ITEM F

DRAFT

LONG SUTTON SIGNAGE

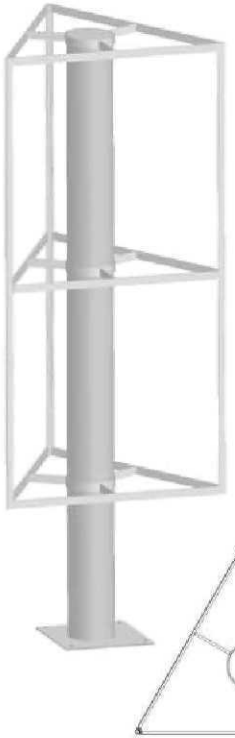
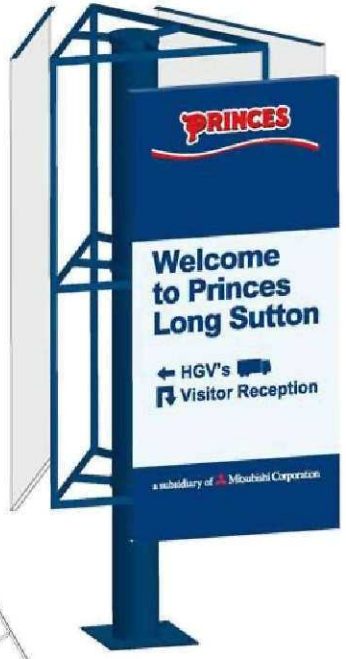
The location of this sign must be moved to be in line with the car park (curtilage) and existing sign.
The site has requested that access is required under the tower for grass maintenance and vermin control.
The highways agency have been consulted and have asked to be kept informed
but do not see any issues as long as we move the sign in line with the existing sign as suggested above.
